DEVELOPMENT APPLICATION ASSESSMENT REPORT

Application Number:	DA2022/0673
----------------------------	-------------

Responsible Officer:	Adam Croft
Land to be developed (Address):	Lot 28 DP 203735, 16 Coster Street FRENCHS FOREST NSW 2086
Proposed Development:	Construction of a secondary dwelling and garage
Zoning:	Warringah LEP2011 - Land zoned R2 Low Density Residential
Development Permissible:	Yes
Existing Use Rights:	No
Consent Authority:	Northern Beaches Council
Land and Environment Court Action:	No
Owner:	Thomas Michael Cooney Helen Maria Cooney
Applicant:	Helen Maria Cooney

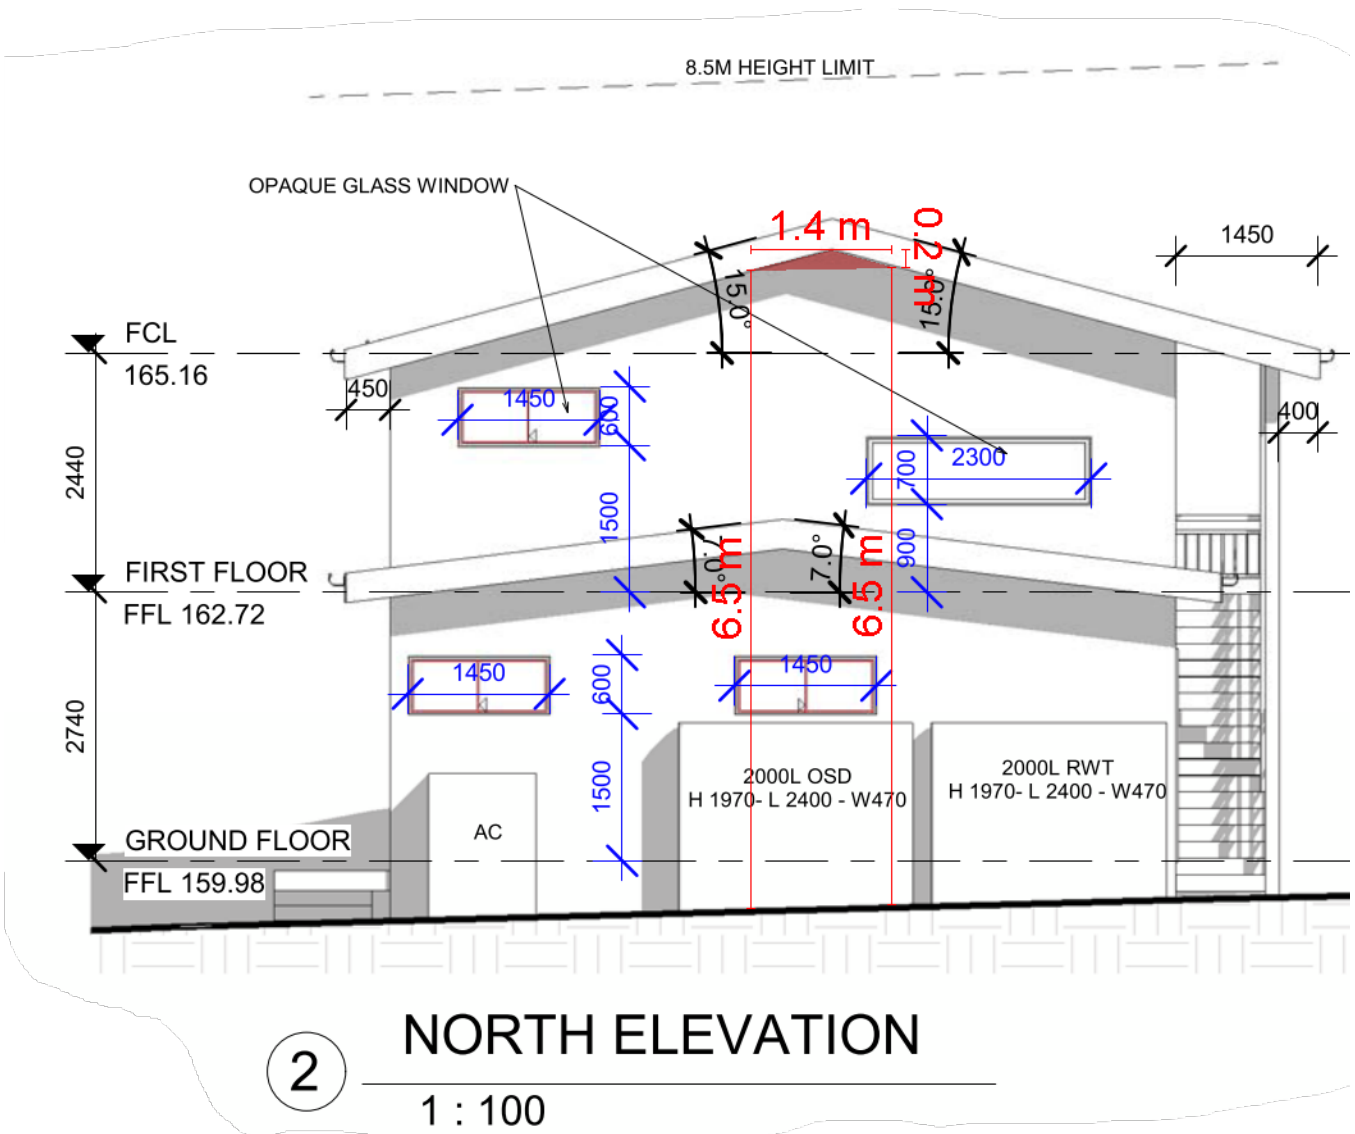
B3 Side Boundary Envelope

Description of non-compliance

The proposed secondary dwelling results in a minor breach of the building envelope control at the first floor level as shaded on the northern elevation plan below.

The amended proposal provides a 2.5m setback to the first floor and is adequately articulated at the northern elevation. The proposed breach occurs immediately below the gable roof and does not result in unreasonable visual impact, height or building bulk.
